# APPENDICES

**RE: PONDEROSA PARADE AND JUBILEE AVENUE, WARRIEWOOD**

This letter report supplements previous reports dated February 2011 and 8 June 2011 for the development of a road to connect 120 Mona Vale Road, Warriewood.

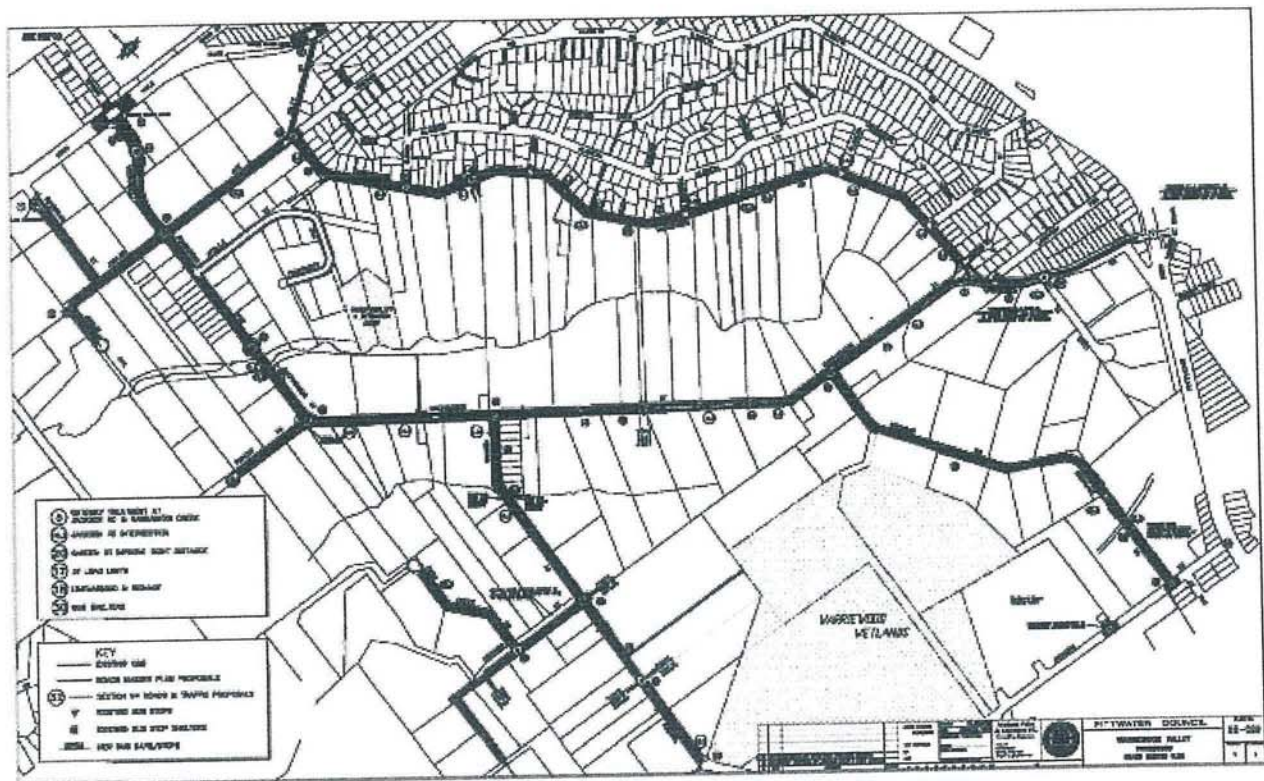
**Item 6.** *The proposed intersection design of the proposed road and Jubilee Avenue is not acceptable and does not reflect the design in the WVRMP.*

The WVRMP states that the bend of Jubilee Avenue (to the west of Daydream Street) is under its priority controls for intersections (section 3.7.1) and mentions that a layout for this bend is within the Roads Master Plan drawing (below).

Council have supplied a CAD drawing to us showing Council's draft design for the amendment of the Jubilee Avenue intersection. We have incorporated the proposed changes into the intersection which include placement of two concrete traffic islands and repositioning of the kerb on the inner radius of this bend. The traffic islands will control the traffic entering and exiting the proposed road onto Jubilee Avenue establishing Jubilee Avenue as the dominant road. This will also improve the safety of the intersection by reducing the traffic speed. The kerb on the inner radius of the bend in Jubilee Avenue will be repositioned to increase the carriageway width creating a larger turning radius for trucks. This was part of the Council draft design.

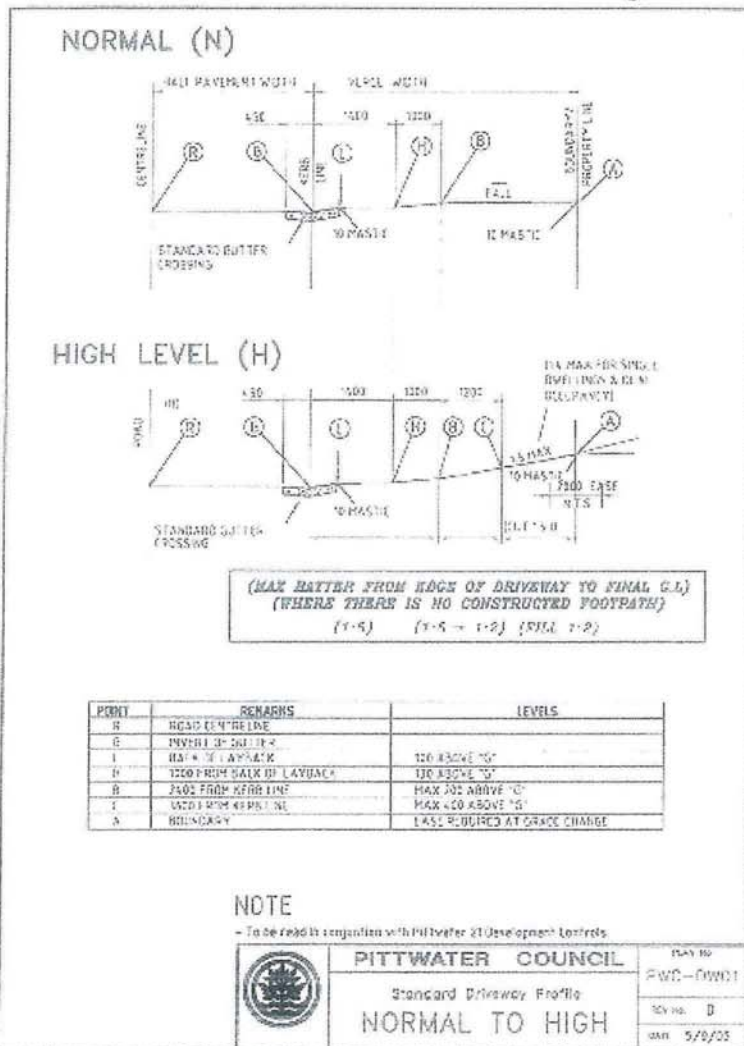
**Item 8.** The proposed intersection of the proposed road with the existing ROW to the Uniting Church needs to be designed in accordance with Pittwater 21 DCP, B6.2.

- Safe and convenient access
- Restriction of visual impact of driveways is reduced.
- Pedestrian safety
- An effective road drainage system
- Maximise the retention of trees and native vegetation in the road reserve
